DESIGN/PROCESS CHANGE NOTIFICATION

FDY100PZ	FDY100PZ_G	
----------	------------	--

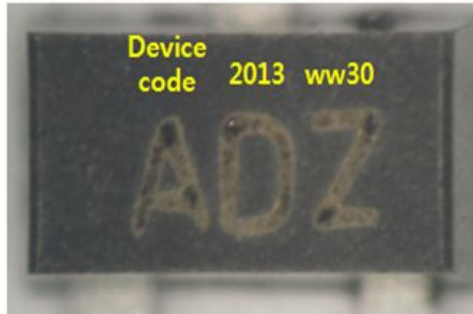
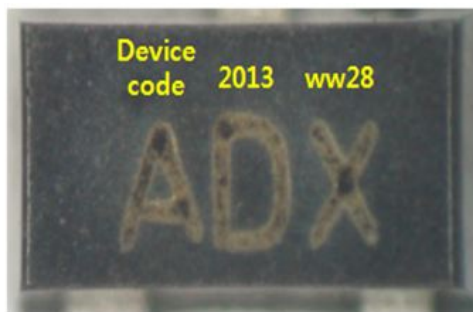
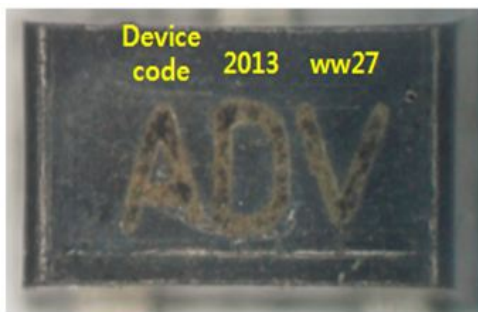
Description of Change (From) :
Laser Marking layout based on Monthly code.

Description of Change (To) :
Laser Marking layout based on Weekly code.

To improve lot traceability and narrow down for risk range
